**BREAKER
TECHNOLOGY,
INC.**
an ASTEC company

Product Release

No. PB2000-016

NEW Model Breakers

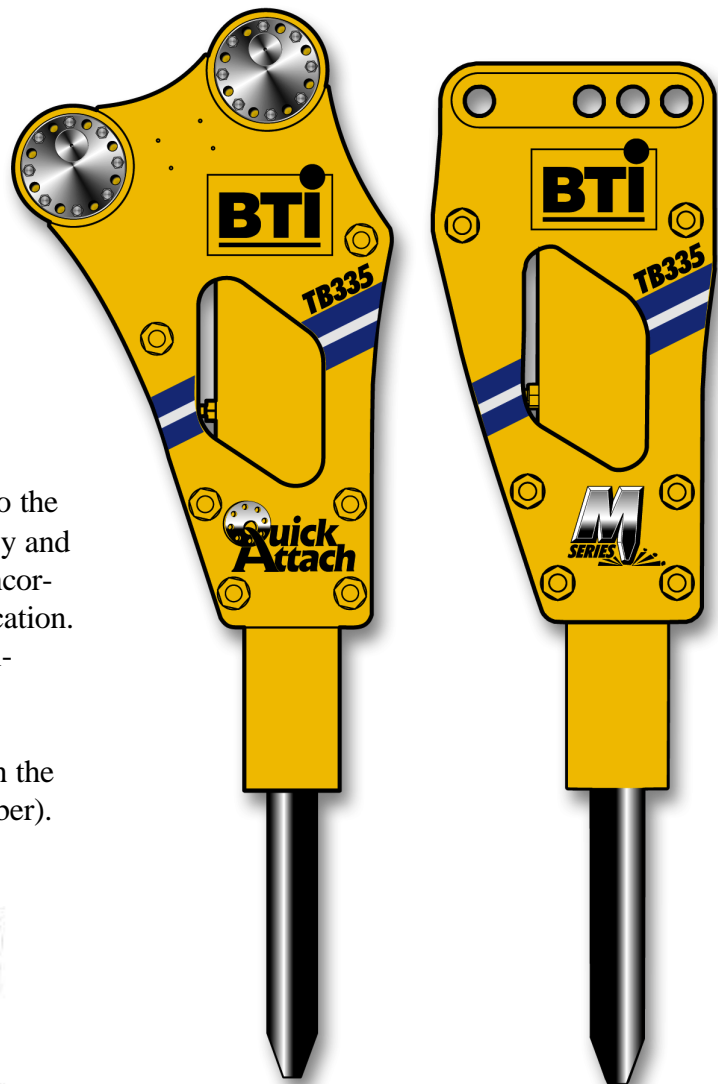
Breaker Technology, Inc. (formerly Teledyne Specialty Equipment) is pleased to introduce the new "M" series of hydraulic hammers in the 350 through 850 ft/lb class. The "M" series of breakers will still deliver the same field proven features and benefits as our "E" series breakers.

The new models have the control valve built-in to the main cylinder body, providing improved efficiency and blow energy, based on CIMA testing data. Also incorporated is a separate protected port for auto-lubrication. Auto-Lube packages are available to fit your mini-excavator, skid steer loader or backhoe loader.

All parts are interchangeable with "E" series (with the exception of the cylinder body and cushion chamber).
